www.mcci.com Prototype Soil + Pond Sensor MCCI Corporation Sheet: / File: greenhouse.sch Title: greenhouse.sch Date: 2016-10-11 Rev: 4

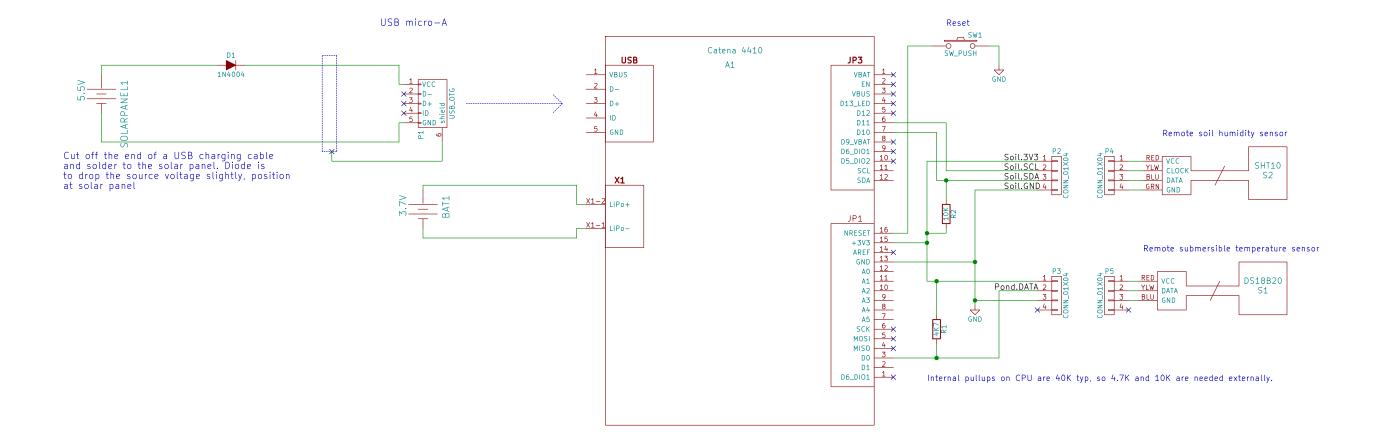
4. Change R1 to 4.7K. Soil sensor is not I2C so reroute to D10 and D11. Add 10K pull—up to Soil.SDA. Improve labels on library for Feature M0 assembly to make the pre—defined pins easier to understand. Make a new library shape for Catena 4410, since that's what this is. Change P3 and P5 to match as—built
